Attachment 1 - Queens Parade Items 9 August 2017_Part1

Agenda Page 12
 Attachment 1 - PLN16/0434 - 26 - 56 Queens Parade Fitzroy North - VCAT(P2079/2016) - PNPE9 - Notice of an Amendment of an Application

Attachment 2 - PLN16/0434 - 26 - 56 Queens Parade Fitzroy North - Officer report on previous substituted plans

Original Plans

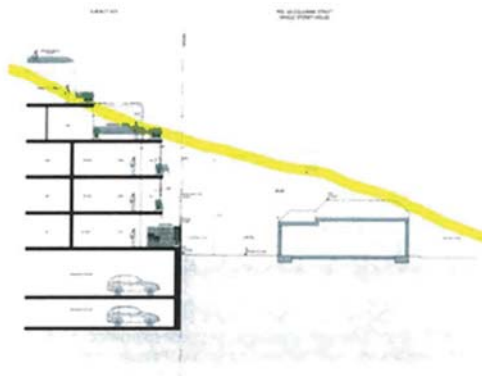
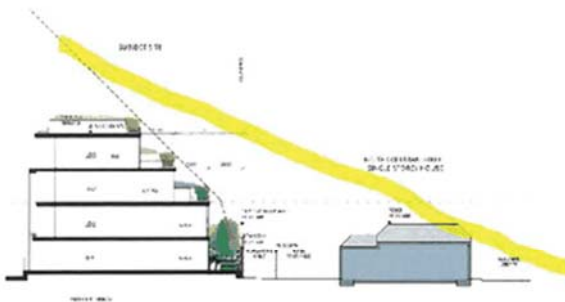
132. Comparing the original and the substituted plans, it is evident that the reduced height and increased setbacks have reduced the impact of the proposal from the north.

133. This is a rather crude method of assessing the impact to the north or from Coleman Street, however it appears that the northern segment of the development may now be acceptable from a streetscape perspective to the north.

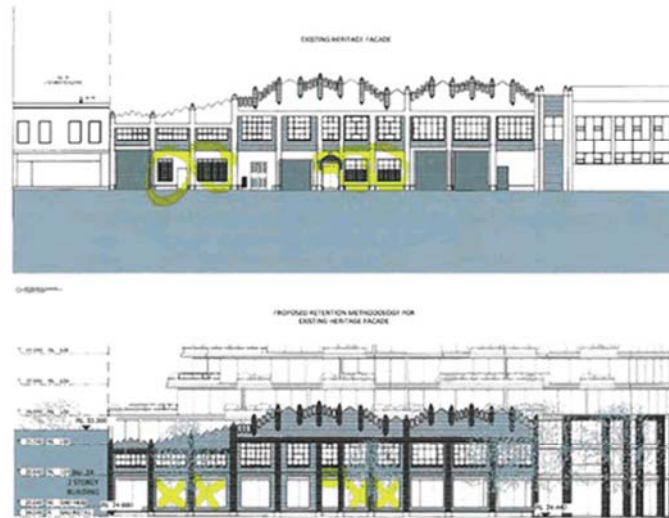
(c) *request details of the framing and glazing to the façade windows, confirming that while the removal of roller doors is acceptable, existing façade wall panels should not be removed.*

142. Whilst the removal of the roller doors is acceptable, 4 of the existing windows should be retained to preserve the heritage fabric, or at least the window framing where balconies are proposed behind. The following marked elevations identify the elements which should be retained to ensure the significance of the heritage place is not unreasonably impacted. This could be addressed by way of a permit condition, should a permit issue.

Comments on building massing

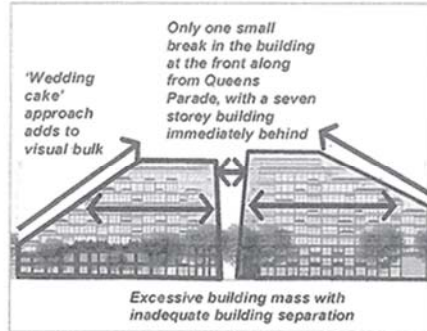
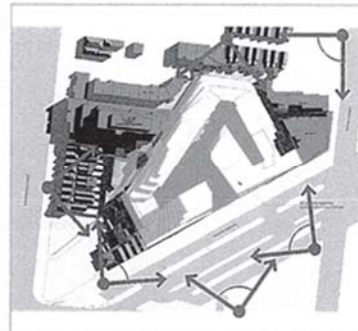
Considering the abovementioned policy at Clause 22.10-3.2, it is advised that the development should be broken up into a series of smaller parts, so that these parts can more adequately respond to the character and constraints of the surrounding properties, and contribute better to the fine grain of urban form. The buildings within each part should be appropriately designed and provide adequate building separation so that each building can be read separately.

Any oblique views (such as the examples above) will not show any building separation

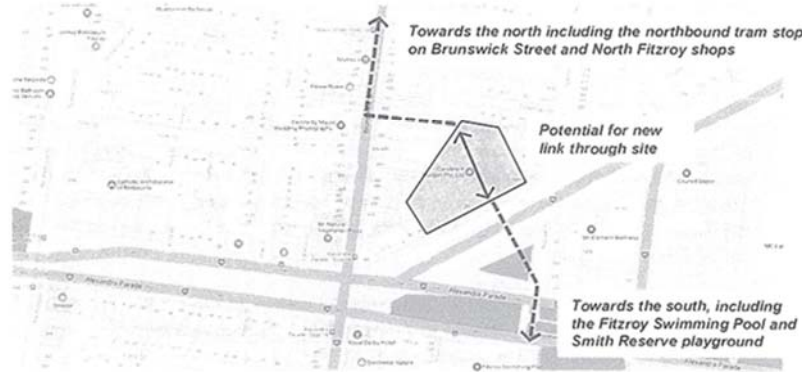
Clause 21.05 (Built Form) seeks under Strategy 28.6 to "require new development to consider the creation of public access through large development sites".

The site is very large, and access is predominately gained from Queens Parade. We consider that there would be a benefit from providing a link through the development as this would improve permeability through the site, make the development feel less like a gated community, make the ground floor café/shops more inviting/accessible and enhance links to the north towards Brunswick Street and St Georges Road. The link could potentially extend through the middle of the site and connect to Grace Lane, as illustrated on the map below. This would require some discussion with the Department of Health and Human Services, who we understand owns Grace Lane and the adjoining land.

- **Façade design and materials/colours**

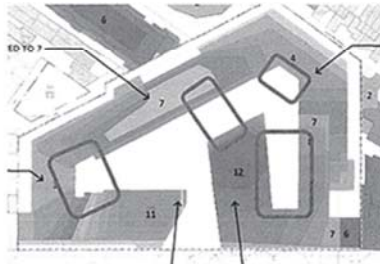
As mentioned in the 'Massing' section above, the terraced approach to the building form and lack of building separation has created an overly prominent building, and it is considered that the repetition of the design detailing of the building also accentuates the overall mass of the development. It is noted that although the front façade of the building has tried to reflect the rhythm and spacing of the heritage building, the overall detailing is very repetitive on all façades of the building, which accentuates the building as one large mass. As recommended above, the development needs to separate the site into smaller parts and adopt a block design approach. This should include appropriate changes in the design and materials/colours to help the buildings to read as separate.
